AMENDMENTS TO THE DRAWINGS

REMARKS

Figure 2

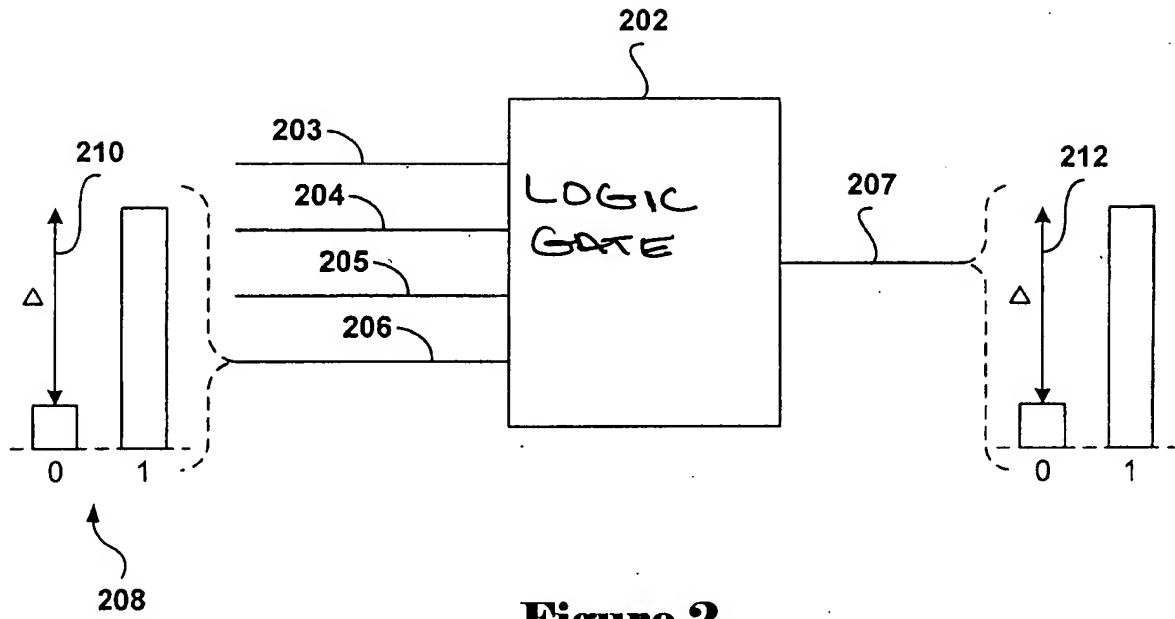
Claims 1-20 are pending in the current application. In an Office Action dated December 7, 2005 ("Office Action"), the Examiner objected to Figure 2, objected to claims 1, 3, 5, 7, 9, 12, 14, 16, 18, and 20, and indicated that claims 1-20 would be allowable once the objections have been addressed. Applicants' representative would like to thank the Examiner for the conditional allowance of claims 1-20. Applicants' representative has addressed the objection to Figure 2 in the above amendments to the drawings, and has addressed certain of the claim objections in the above amendments.

Figure 2 is presented with redline corrections. A new set of formal drawings is also submitted for approval.
